Access Compliance Report Public Rights-of-Way (Curb Ramps)

Main Street: MERCANTILE_WAY		Cross Street: N/A		Location: E
ADA ID: RPRK211029122532	Ramp Type: Type 4 - Parallel	Initial Pass/Fail: Fail	Overall Compliance: No	Severity Score: 30

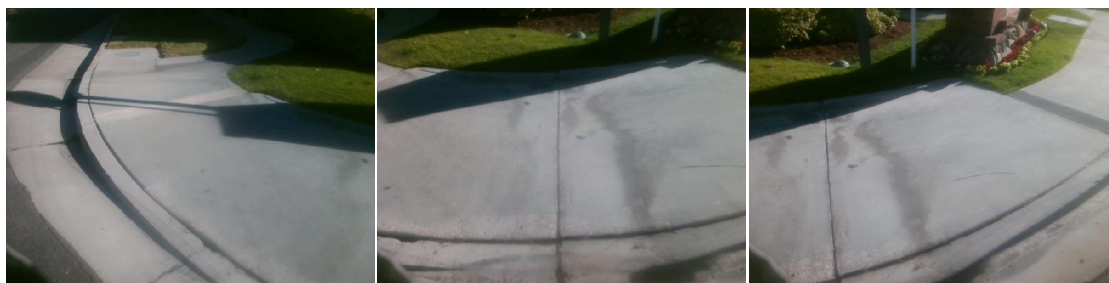
Compliance	Description	Data	Compliance	Description	Data
N/A	Ramp Length LT (in)	110	N/A	Ramp Length RT (in)	110
Yes	Ramp Width LT (in)	90	Yes	Ramp Width RT (in)	90
Yes	Ramp Run Slope LT (%)	1.1	Yes	Ramp Run Slope RT (%)	5.2
Yes	Ramp Cross Slope LT (%)	1.4	No	Ramp Cross Slope RT (%)	9.5
N/A	Landing Present	N/A	N/A	DWS Provided	N/A
N/A	Landing Length (in)	N/A	N/A	DWS Contrast	N/A
N/A	Landing Width (in)	N/A	N/A	DWS Length (in)	N/A
N/A	Landing Run Slope (%)	N/A	N/A	DWS Full Width	N/A
N/A	Landing Cross Slope (%)	N/A		DWS Offset Type	N/A
N/A	Landing Movement Obstructed?	N/A	N/A	DWS Offset Left (in)	N/A
	Landing Movement Type	N/A	N/A	DWS Offset Right (in)	N/A
N/A	Landing Shared	N/A			
N/A	Clear Space	Yes			
N/A	Clear Space To Crosswalk (in)	N/A			
N/A	Marked Crosswalk 1	No	N/A	Marked Crosswalk 2	No
	Crossing 1 Direction	NW		Crossing 2 Direction	SW
	Marked Crosswalk 1 Width (in)	N/A		Marked Crosswalk 2 Width (in)	N/A

Remove & Replace Curb Ramp With Two New Directional Ramps or Equivalent.

R204.3, R304.5.3, STD 1115
